OUTFALL MODIFICATION FORM

Permit Tracking No. ARR00 0231 AFIN: 72-00144

Re: ARR000231 - Eco-Vista, LLC

<p>SITE LAYOUT</p> <p>STORMWATER POLLUTION PREVENTION PLAN</p> <p>ECO VISTA LANDFILL</p> <p>SPRINGDALE, ARKANSAS</p>	<p>PROJECT NO.:</p> <p>190166</p> <p style="font-size: 2em; font-weight: bold;">2</p>
--	---

Outfall 004

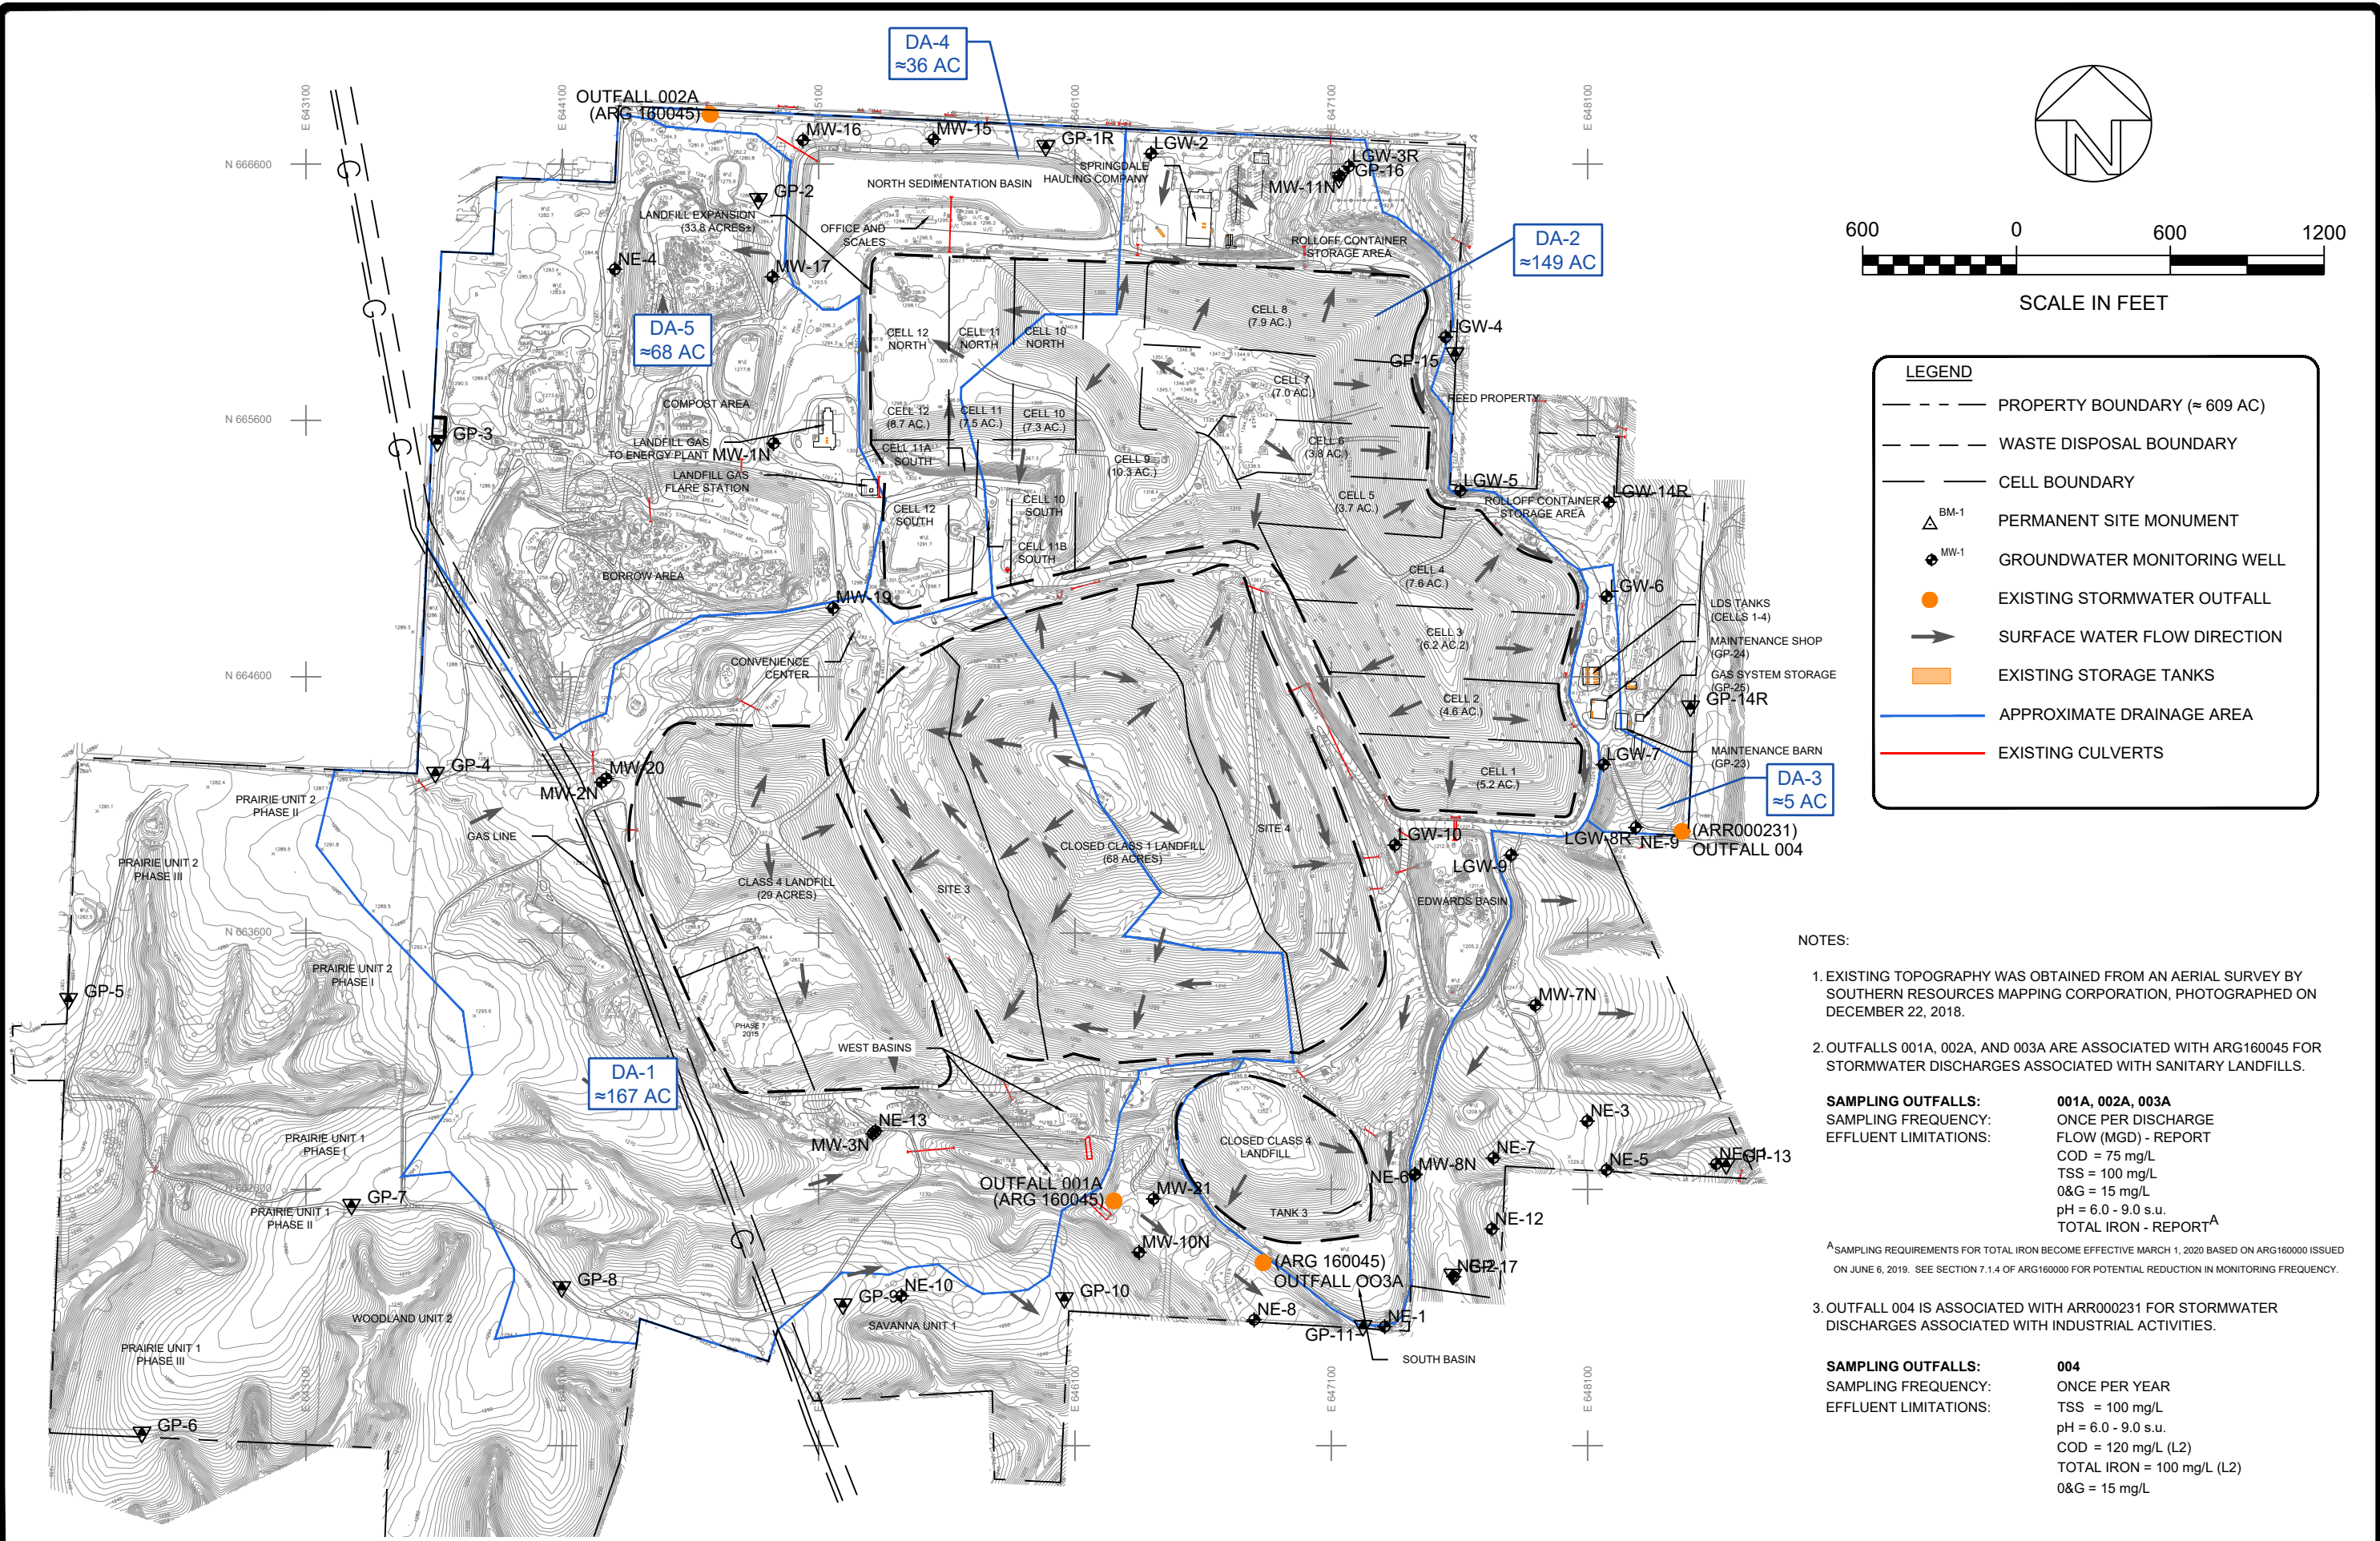
1. Is there an outfall associated with Drainage Area - 5?
Attached is an outfall modification form that DEQ received.

No there is not an outfall associated with Drainage Area 5. This area is primarily the site's soil borrow area for landfill operations and stormwater runoff typically sheet flows into the lower elevation areas of the borrow area. Typically, no stormwater is discharged from this area. However, if stormwater was to be pumped from the borrow pits, it could then be discharged into either Drainage Areas 1 (south) or 4 (north). Please let me know if you should have any other questions or comments. Thanks!
